BLOCK 4 SECTION 46 SUBURB TURNER - S144B

DEVELOPMENT APPLICATION: 201833361

The Applicant has lodged an S144 Amendment on **27/8/18**.

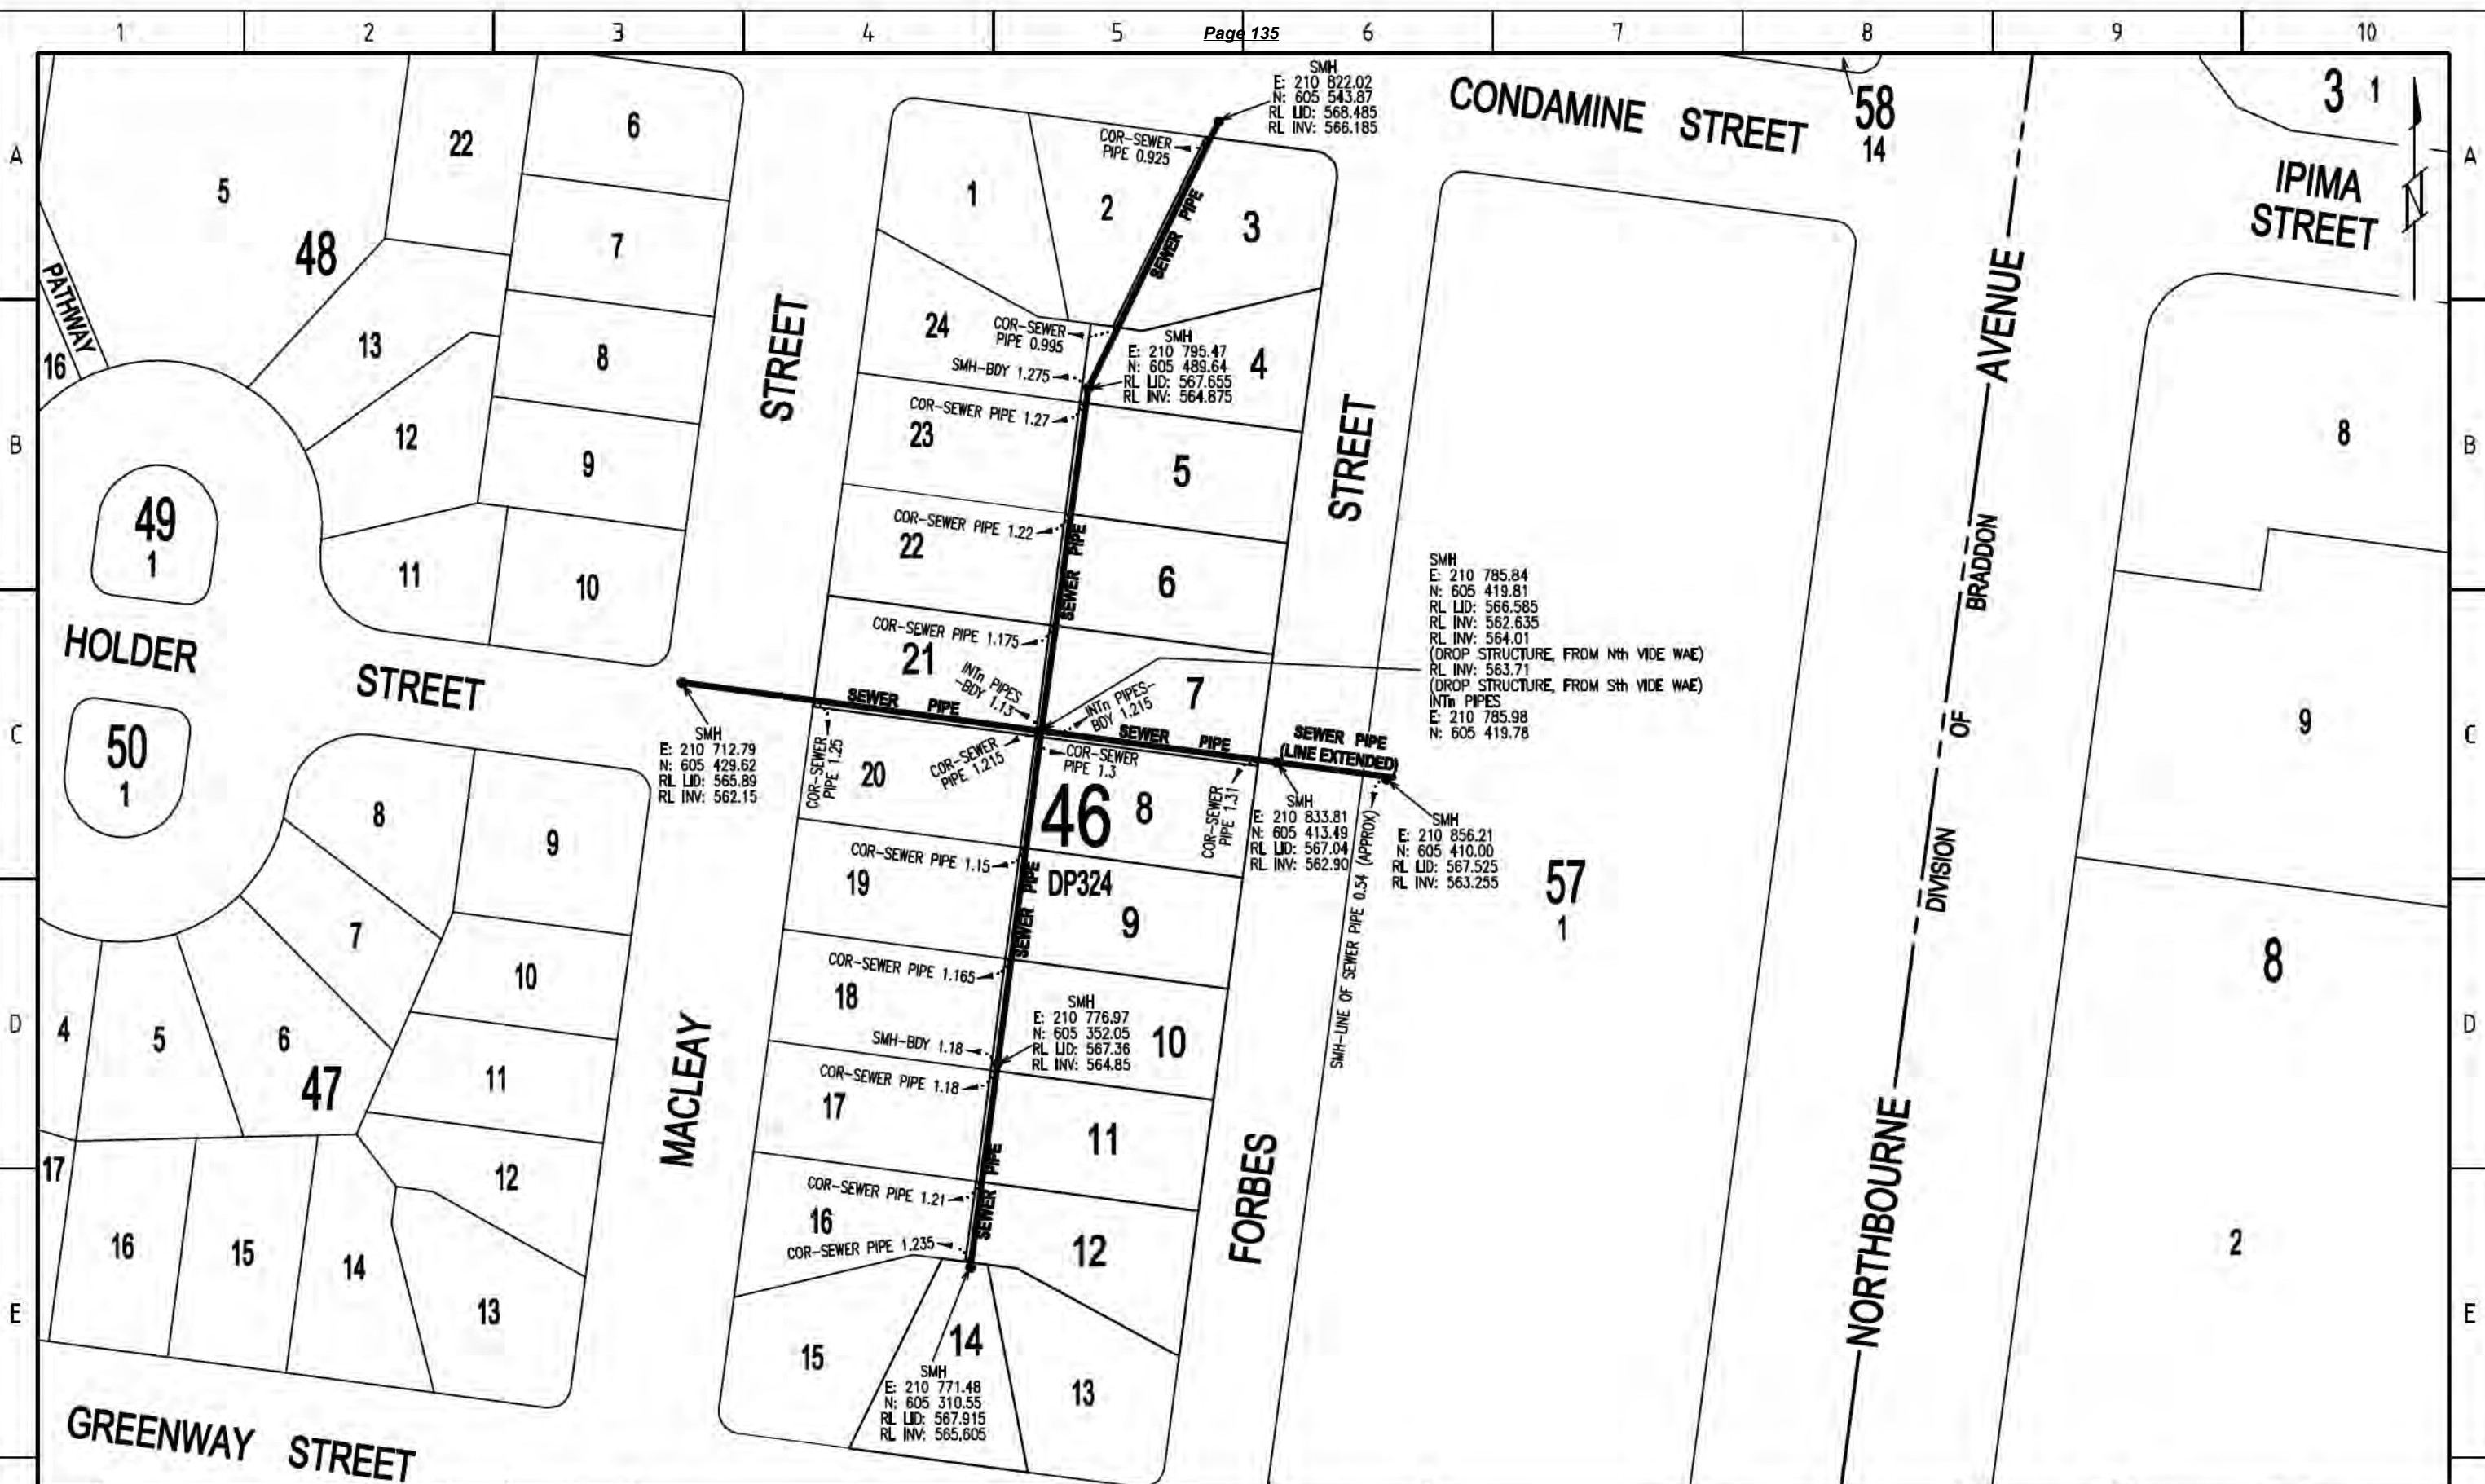
Details of Icon Waters sewer and/or water networks need to be shown on the plan/s

Comments: Using survey attached, show location of sewer pipe in easement on site plan and all relevant dimensions, boundaries to proposed structure, sewer pipe to proposed structures.

The design depicted in this document is not accepted because it fails to comply with conditions listed on the accompanying statement.

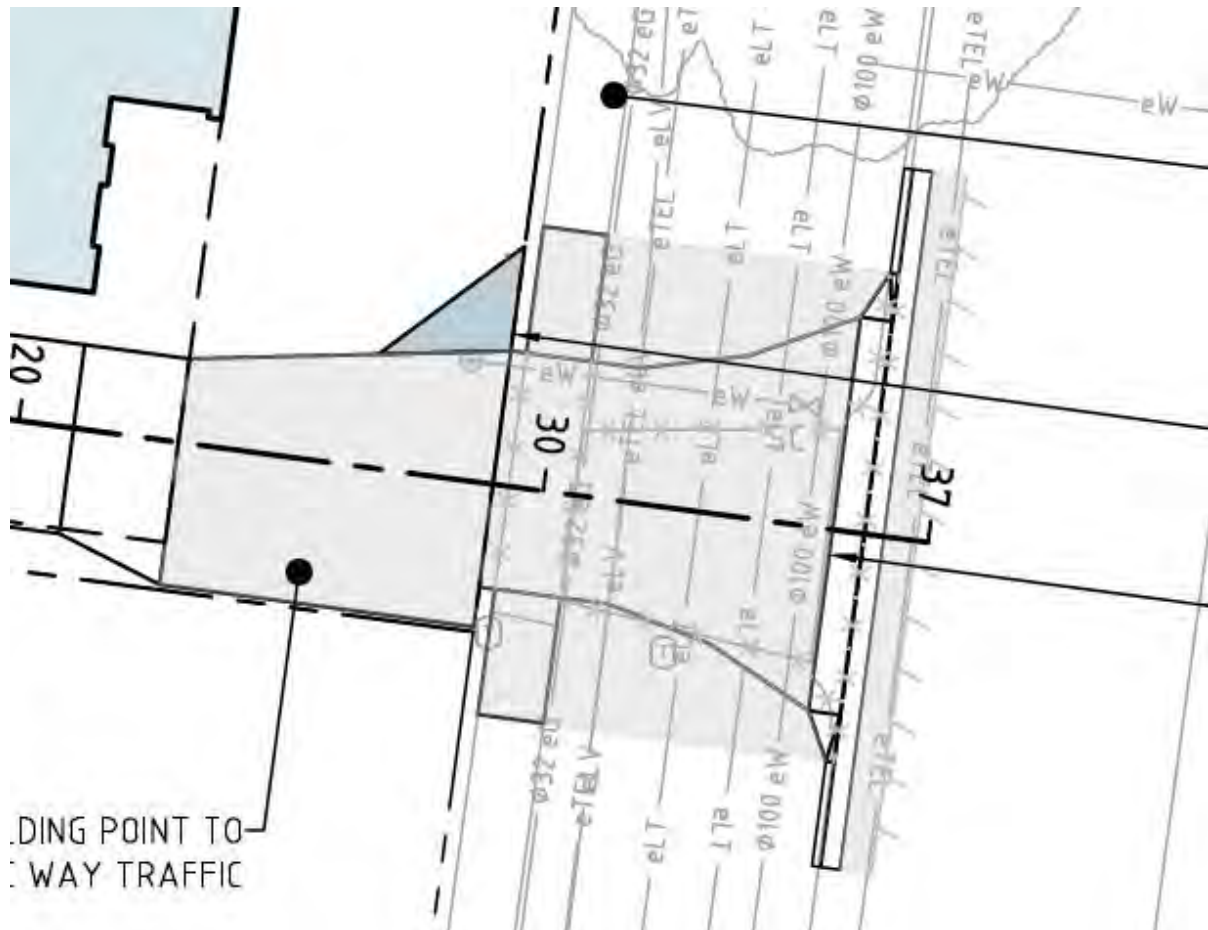
Driveway in pavement plan and ground level plan don't match

R72 of the MUHDC states:

Driveway verge crossings comply with all of the following:
